Indianapolis Historic Preservation Commission (IHPC)  
**HEARING AGENDA**

Wednesday, April 2, 2025, 5:30 P.M.  
2nd Floor, Public Assembly Room, City-County Building  
200 East Washington Street, Indianapolis, Indiana

**2025-COA-051 (IRV) &  
2025-VHP-002**

**2024-COA-406 (LS)**

**April 2025 Rendering**

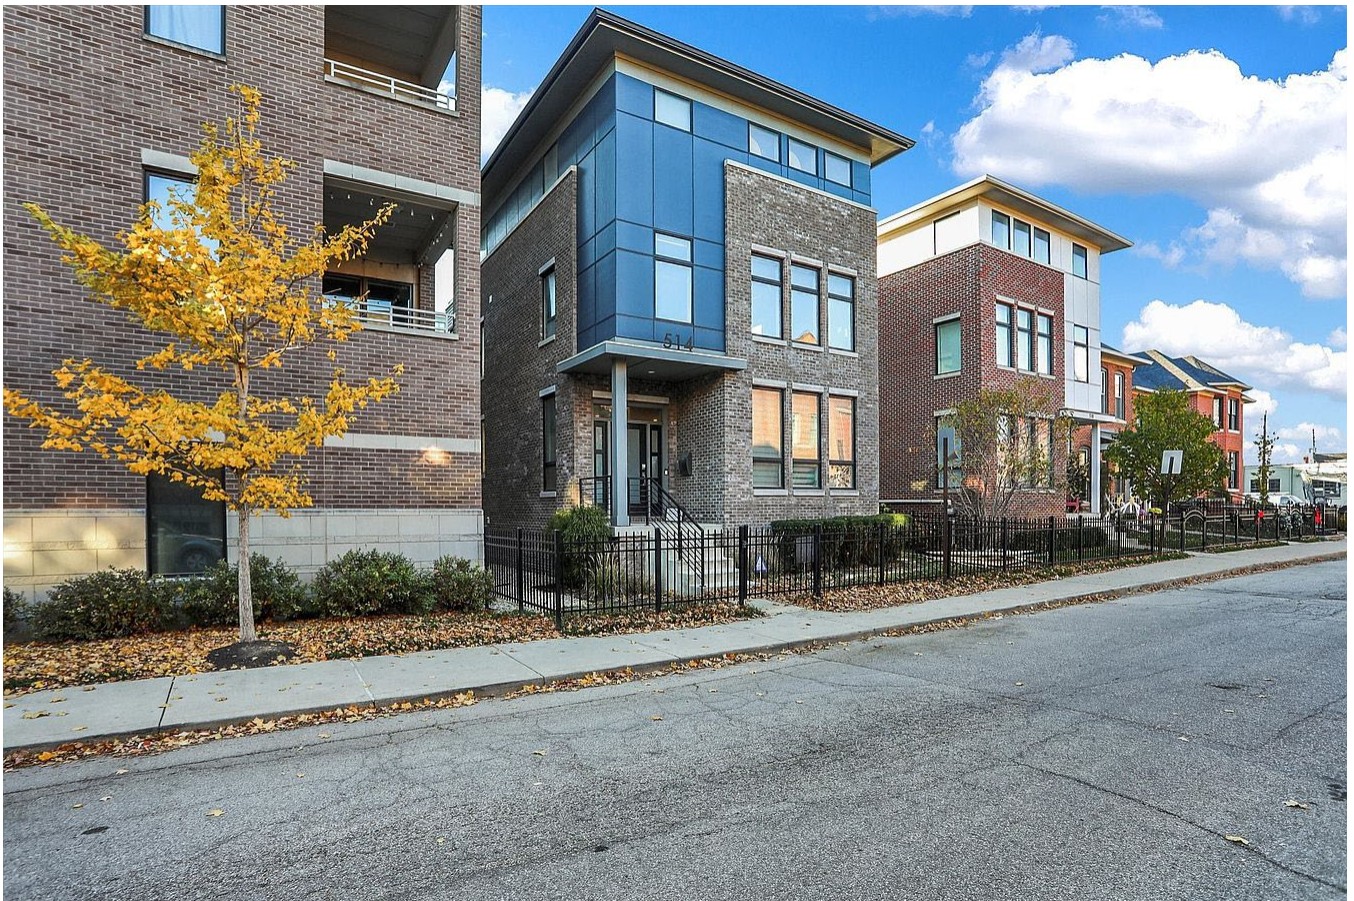
Staff finds the revised design a significant improvement from the March submission. The enlarged projecting north façade bay helps provide depth. The use of paintable architectural panels as opposed to the NewTech product is more consistent with other new construction in the area, as does the additional use of masonry added back to the front façade. The front façade panel insets with ganged windows relate to the north bay, tying together the architecture of the building.

**To approve** amendments to previously approved plans (544 N. Park Avenue Building only), per the submitted plans and subject to the following stipulations:

Submitted site plan with relocated fence out of the right-of-way

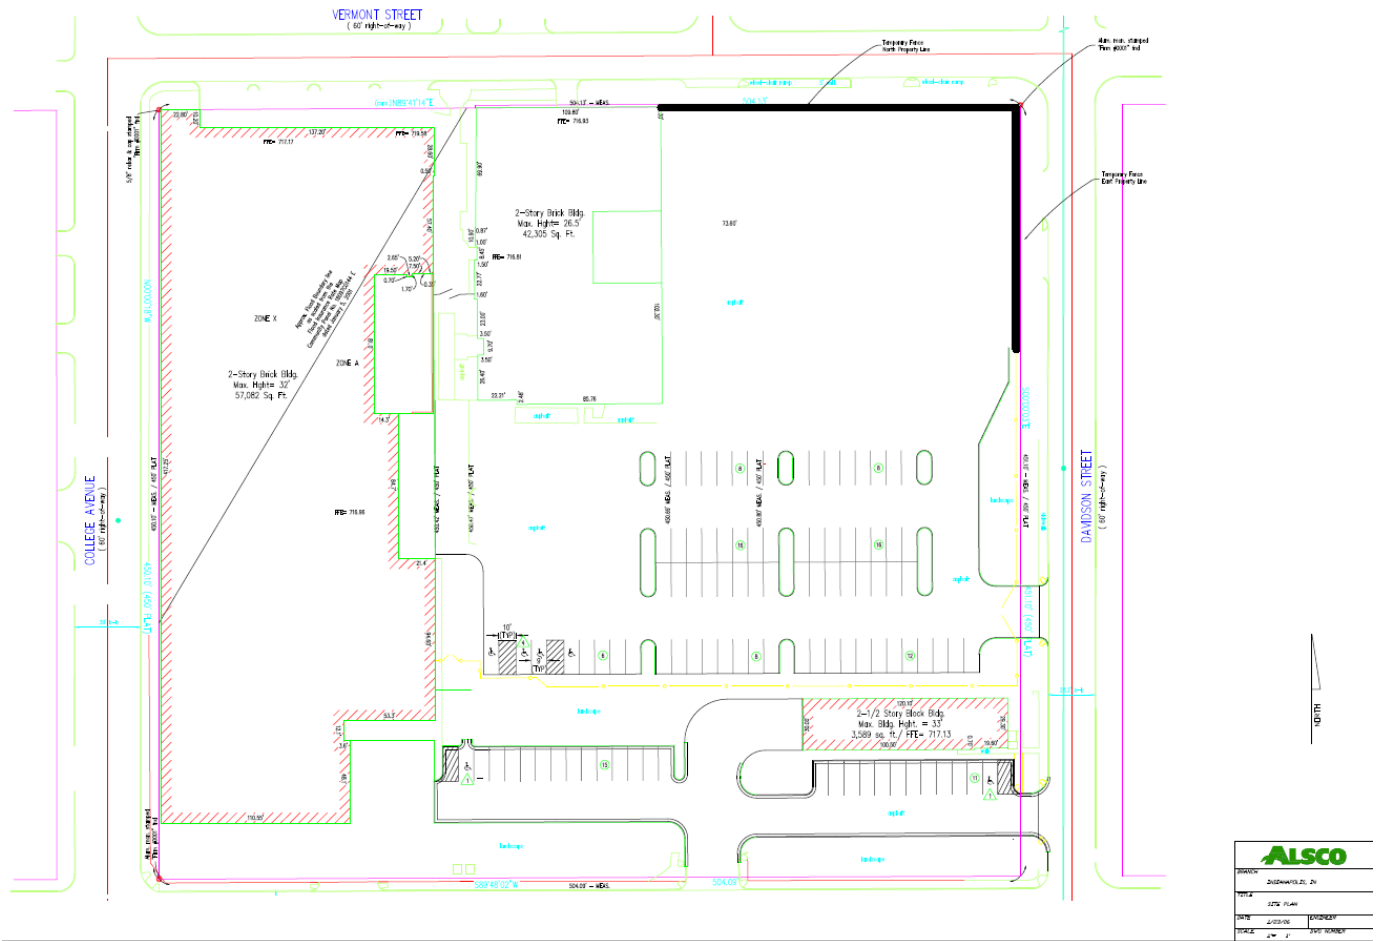
The request is to retain the 6' tall chain link construction fencing installed around the parking lot. This fence is not anchored into the ground. The applicant has agreed to relocate the fencing back onto their own property, so it is out of the right-of-way. They will remove the fencing before they vacate the site for their new location close to the airport.

1. **Fencing must be removed from the right-of-way and installed on the owner's property, per the submitted site plan included in this staff report. Fencing must be relocated no later than April 30, 2025. Approved: \_\_\_\_\_ Date: \_\_\_\_\_**
2. **Fencing must be removed from the site no later than December 31, 2025 or when Alsco vacates the site, whichever comes first. Approved: \_\_\_\_\_ Date: \_\_\_\_\_**

**NORTH**

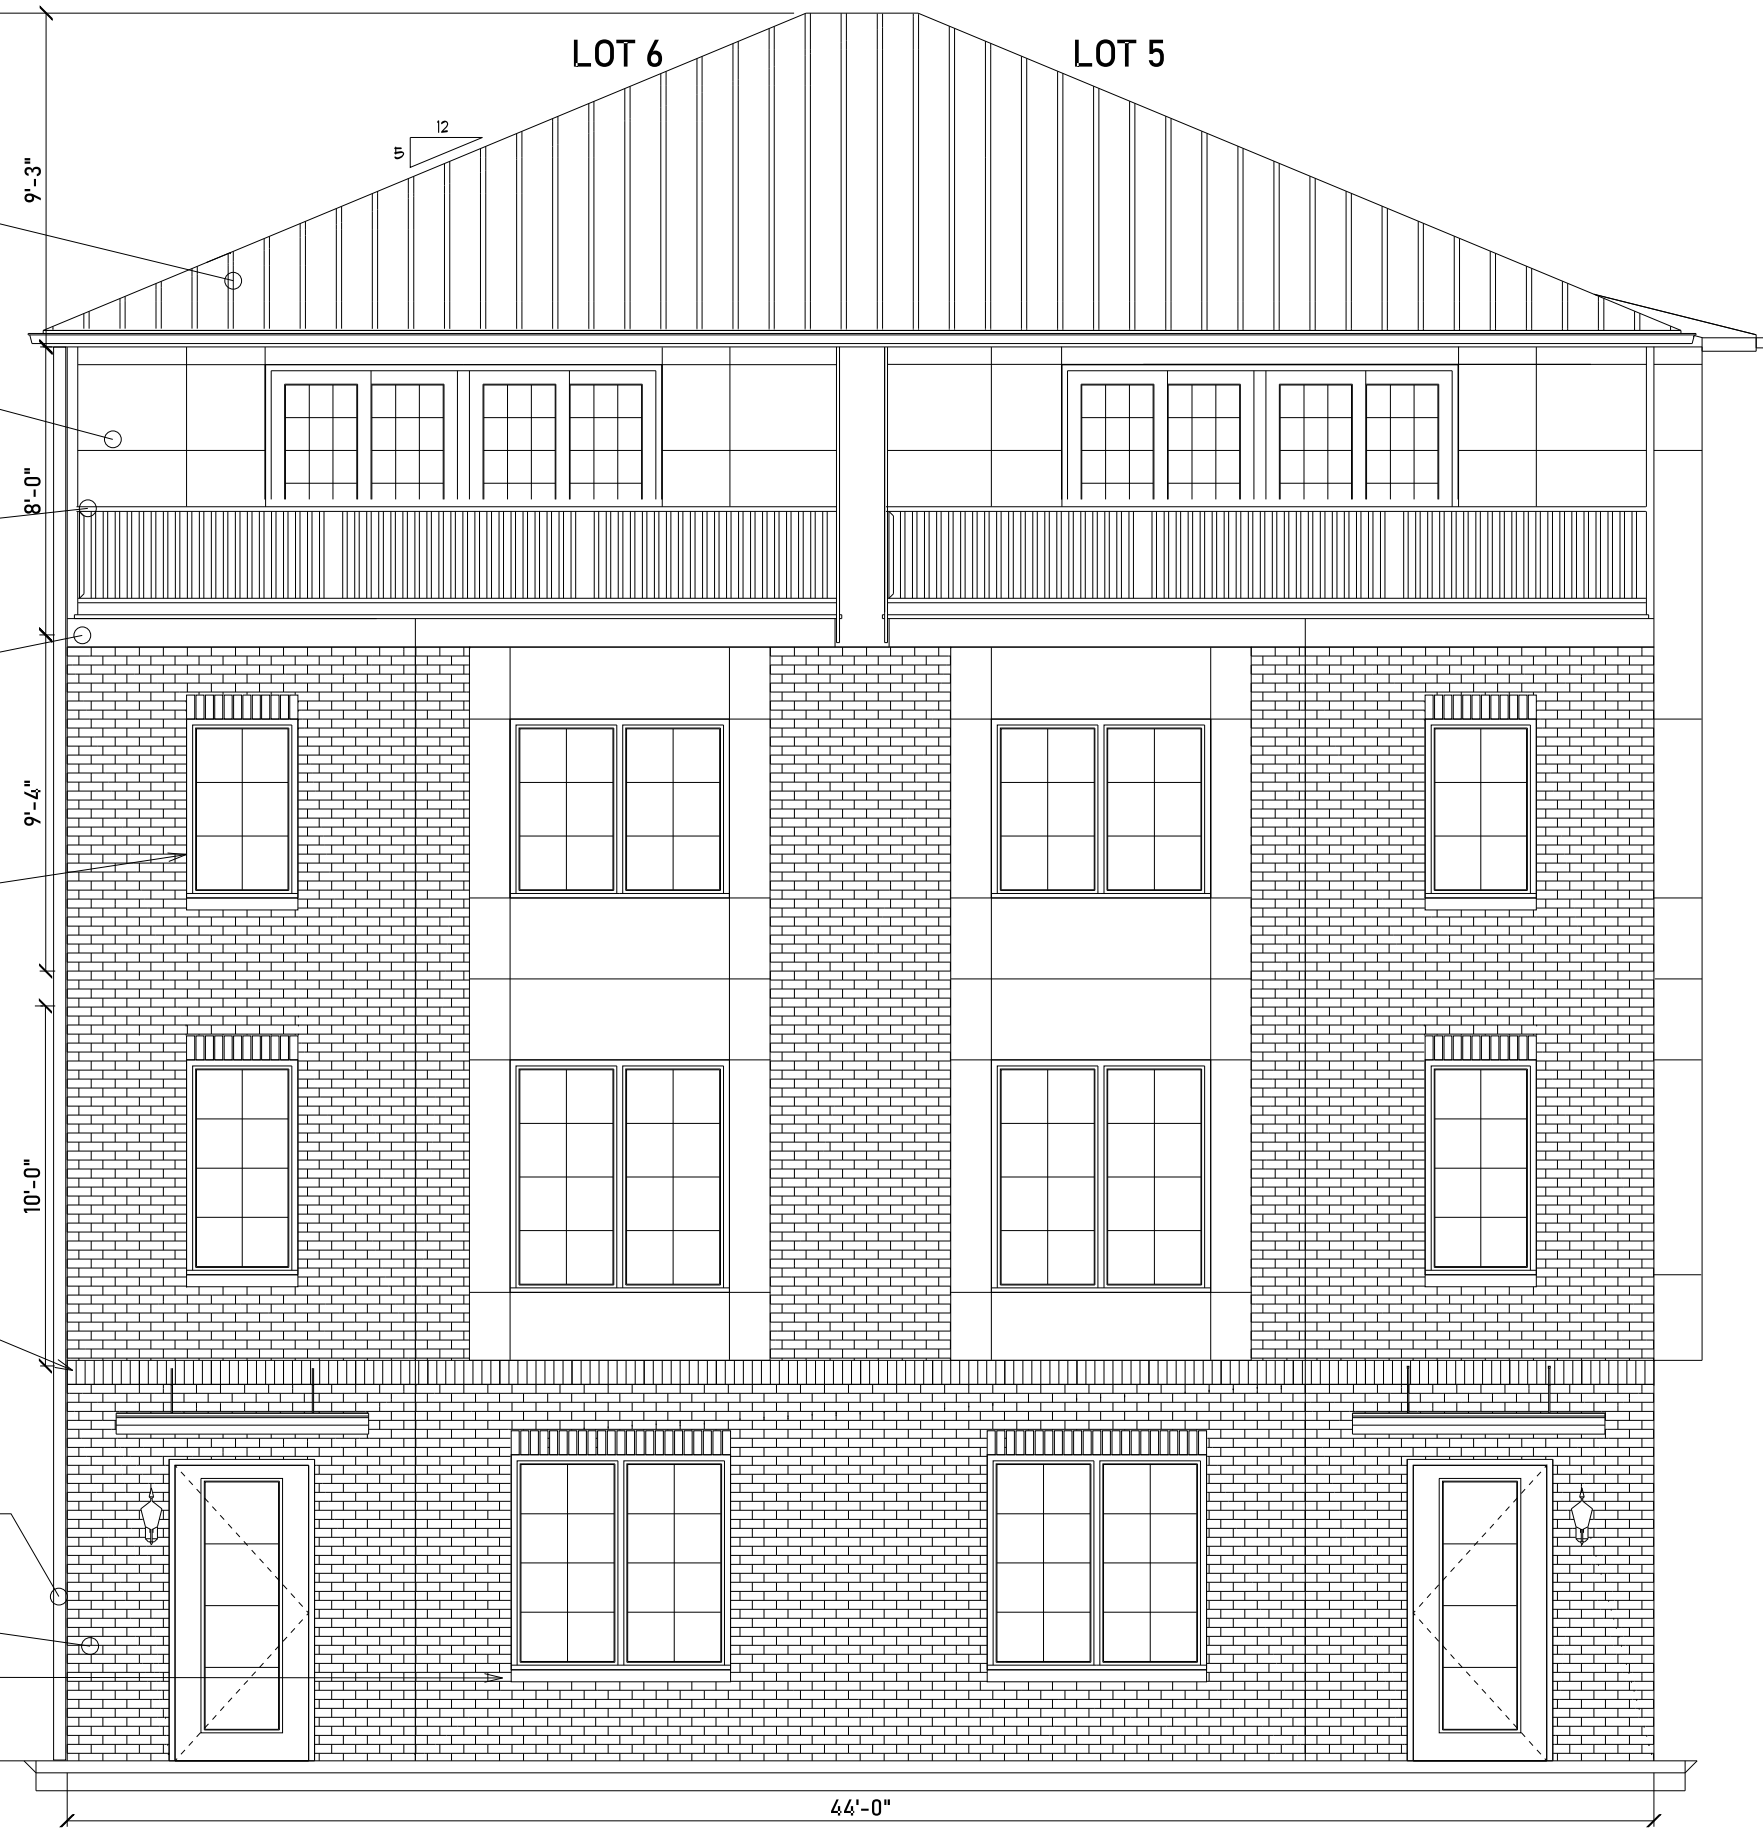
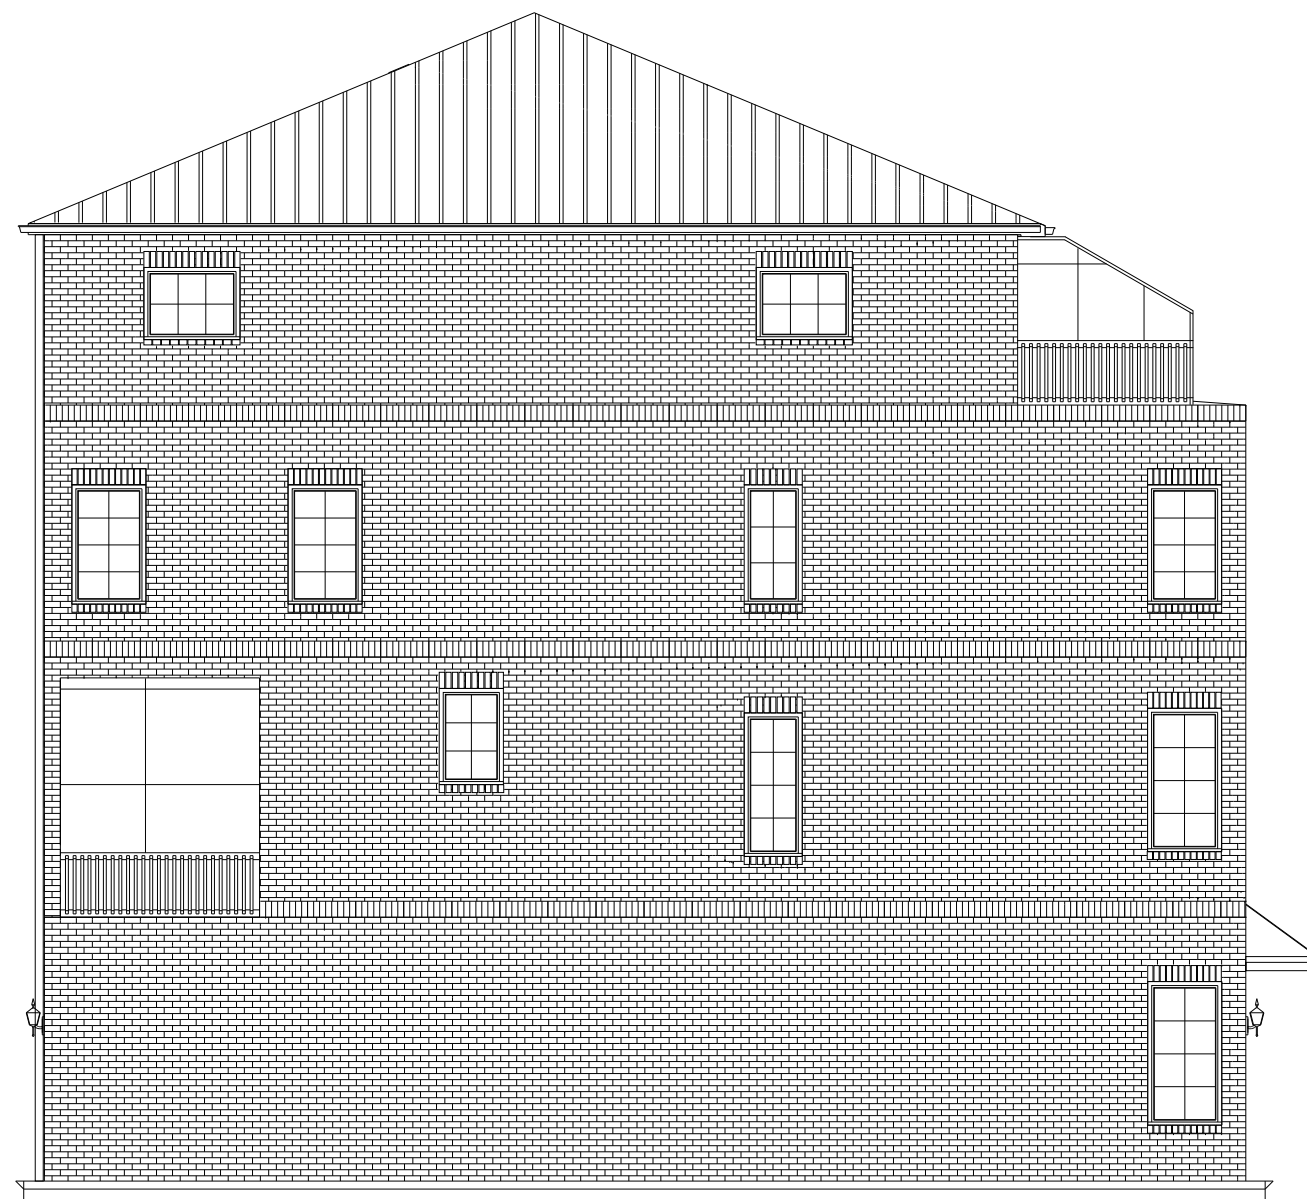
- increased depth of bay
- increased size and count of window on 4th floor bay
- increased size of window at 4th floor Bar
- increased size of window at 4th floor Office
- increased size of window at 2nd floor Bath
- increased size of stair windows 3 floors
- added limestone ledges on North elevation
- added 2 windows to garage
